## DEVELOPMENT APPLICATION ASSESSMENT REPORT

| <b>Application Number:</b> | DA2023/1245 |

| <b>Land to be developed (Address):</b>    | Lot 40 DP 13760, 212 Hudson Parade CLAREVILLE NSW 2107<br>Lot PO 6770, 212 Hudson Parade CLAREVILLE NSW 2107<br>Lot LIC 635271, 212 Hudson Parade CLAREVILLE NSW 2107 |
| <b>Proposed Development:</b>              | Demolition works and construction of a dwelling house including swimming pool   |

Figure 1: Excerpt from the section highlighting the extent of building height above 8.5 metres.

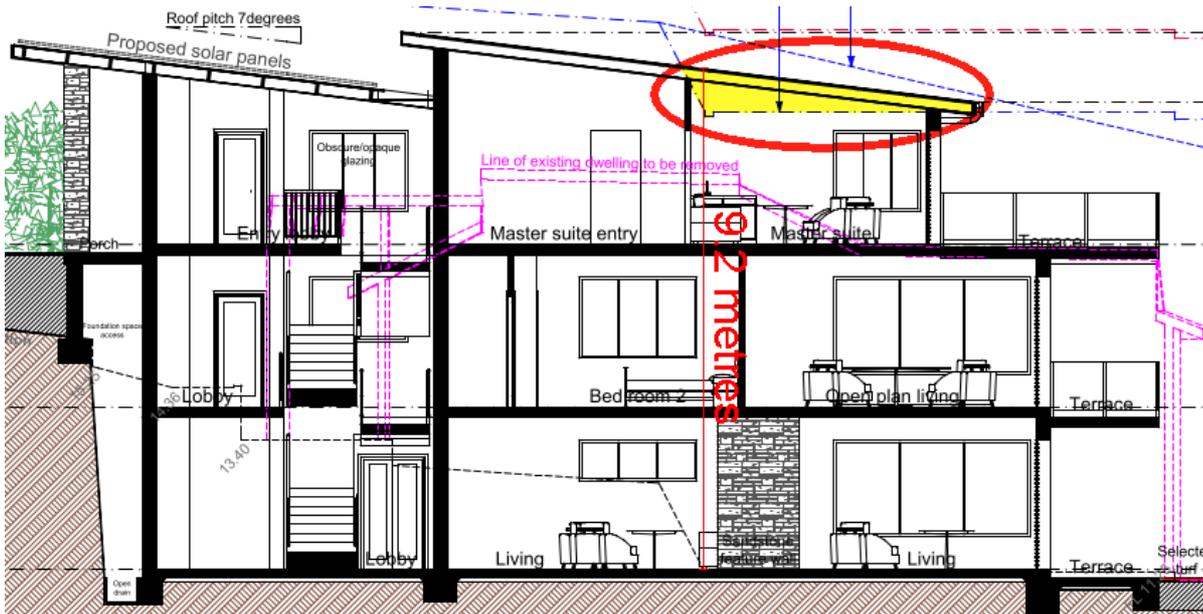
Recent caselaw (*Merman Investments Pty Ltd v Woollahra Municipal Council [2021] NSWLEC 1582*) establishes that height of building is measured to ground level (existing), as per the definition in the Dictionary of the Pittwater Local Environmental Plan 2011 to the highest point of the ridge above. The portion of the development above 8.5 metres is for the purpose of the dwelling roof, thereby not being significant in bulk and scale. The non-compliance arises due to the existing excavation of the site, and the development would be compliant with the 8.5 metres if the natural extrapolated ground level were used for height calculation. The portion of the development in question is shown below highlighted in yellow and circled in red:

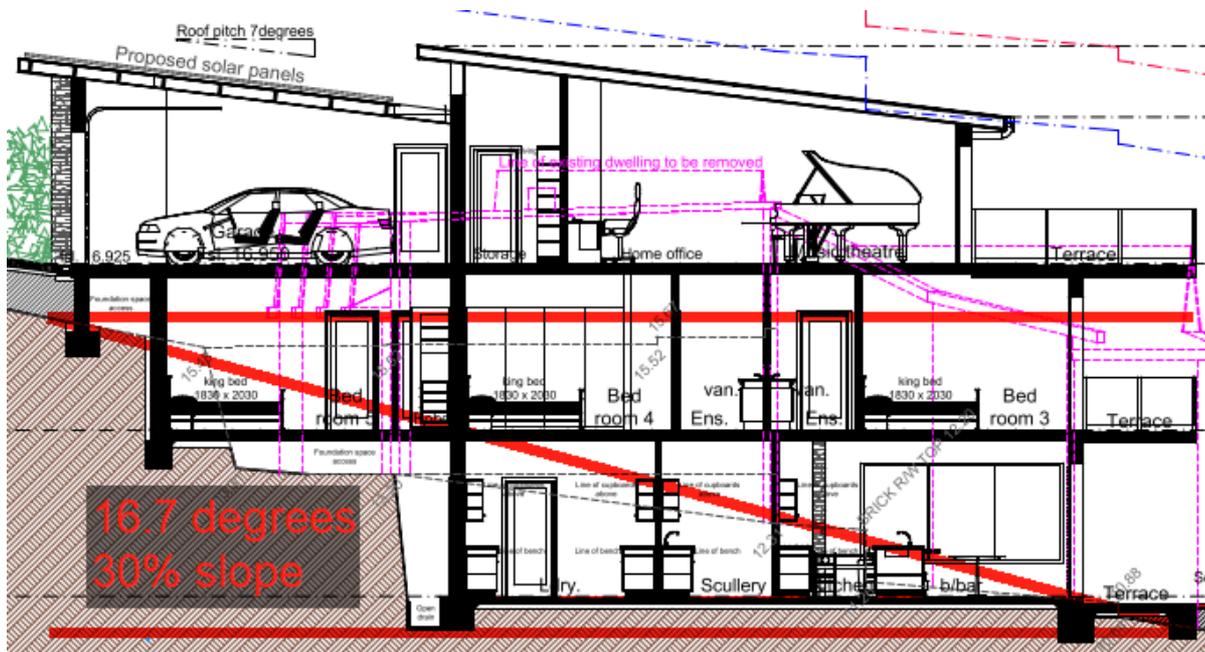
*(e) to encourage buildings that are designed to respond sensitively to the natural topography,*  
Comment:

The proposed development relies on reasonable earthworks for its design. The overall extent of excavation is minimised in this regard. The proposal is also supported by a geotechnical assessment report addressing the earthworks required, which establishes that the earthworks are of acceptable low risk in relation to site stability. Further, the height of building does not exceed 10 metres at any point, and steps down with the slope of the land.

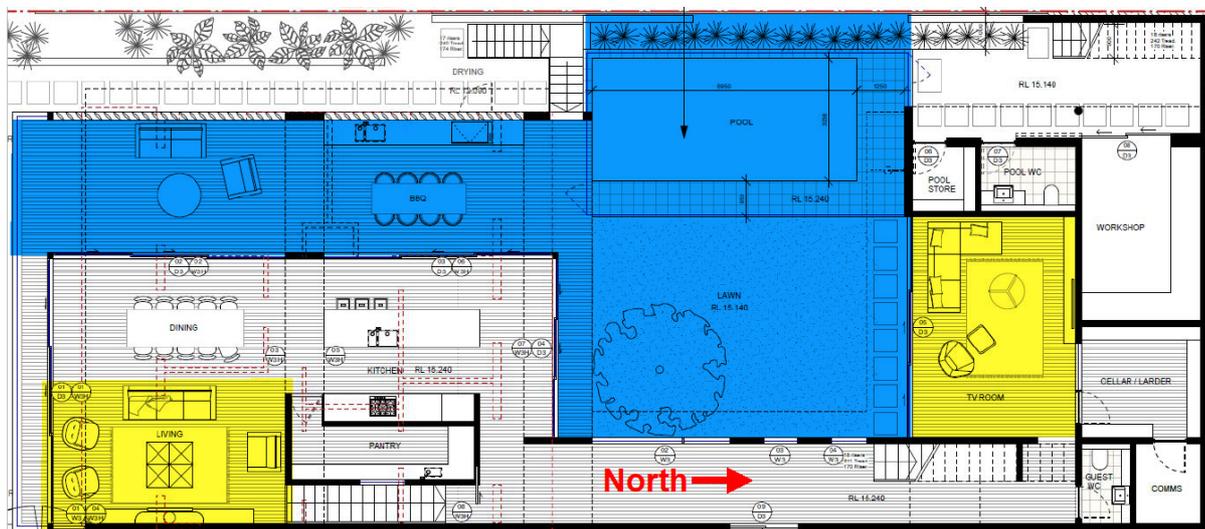
**Comment:**

The proposed development does not prioritise views over canopy trees, as demonstrated by the arborist report that details no tree removal is required.

**D1.11 Building envelope**

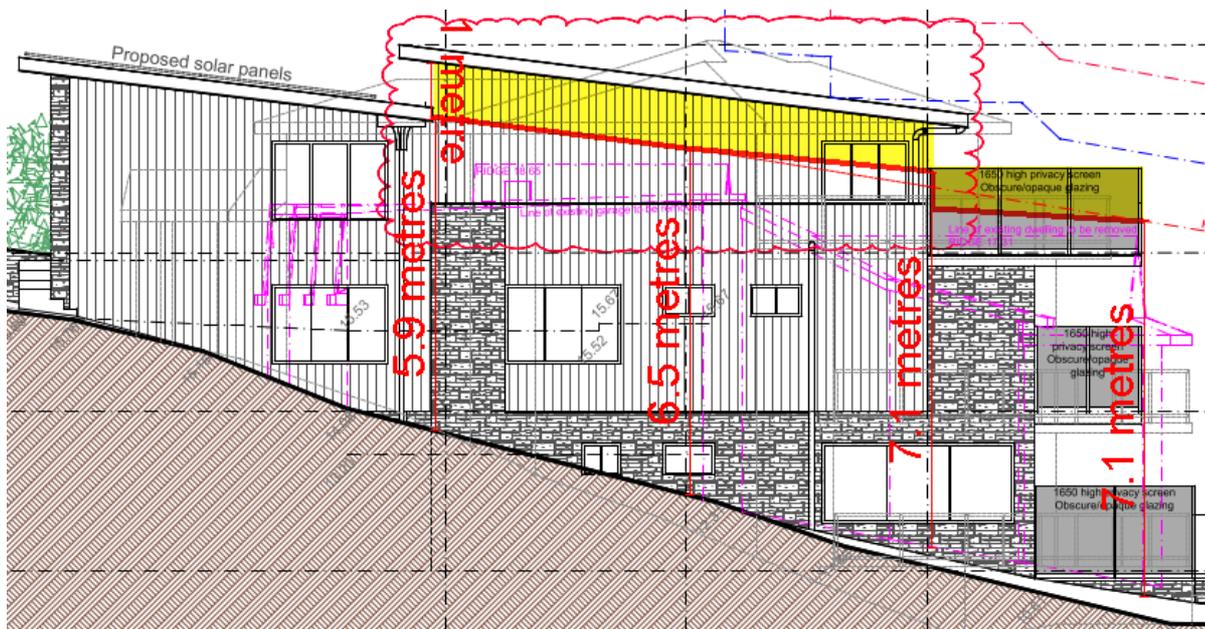
The proposed development includes breaches to the eastern and western elevations of the dwelling house, as follows:

- South-eastern elevation: Max. 800mm outside envelope
- North-western elevation: Max. 1m outside envelope
